**From:** Wooldridge, John  
**Sent:** Thursday, June 11, 2020 12:43 PM  
**To:** Chris E. Howard; James Howard  
**Cc:** Heim, Kimber; Norton, Harvey; Kadakia, Nikunj  
**Subject:** 110412 FAI 037 Safety Project Authorization (NTP) for Appraisals  
**Attachments:** 110412 FAI 037 Authorization 34127 HLS 061120 Executed.pdf

**Subject:** RE: FAI-37-6.34 Preliminary Right of Way Plans (PID No. 110412)

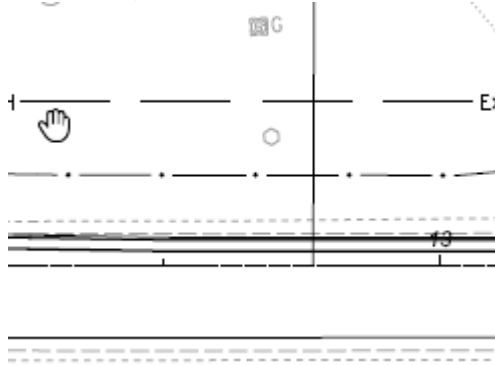
- Missing sheet 20 of 37 as Luke stated.
- Page 21/36 (22/37) Parcel 11-SH shows "Utility Pole Save" for private light poles. I would have them removed as ODOT will need to pay for them anyways (in take area) and would need to do a permit (not recommended) for the poles that are very close to the fence needing removed. Same Parcel has three of those poles (not 2) and also has a small sign near the fence that was not picked up on these plans:

- Page 23/36 (24/37) Can Parcel 12-SH be completely removed? The Construction limits are almost all out of the take and the ditch is in the Ex R/W. Could save some money having one less parcel.
- Page 25/36 (26/37) 14 no take, Please mark encroachment of a singular post:

- PG 31/36 (32/37) We may have future comments about the water building. Pending Village of Thurston review comments. Latest email by Utilities is attached.
- PG 31/36 (32/37) PCL 9 No Take has encroachments to mark for removal (2 of the 3 signs ... last one shown as “save” not in R/W):

- Several pages: “edge of farm field ... SAVE” within R/W is shown; I do not recommend saving that as it will not be permitted and construction company should be able to use all the R/W existing at their discretion. We typically do not label it either save nor remove.
- Legal descriptions were not provided to me and therefore not reviewed against these R/W Plans.
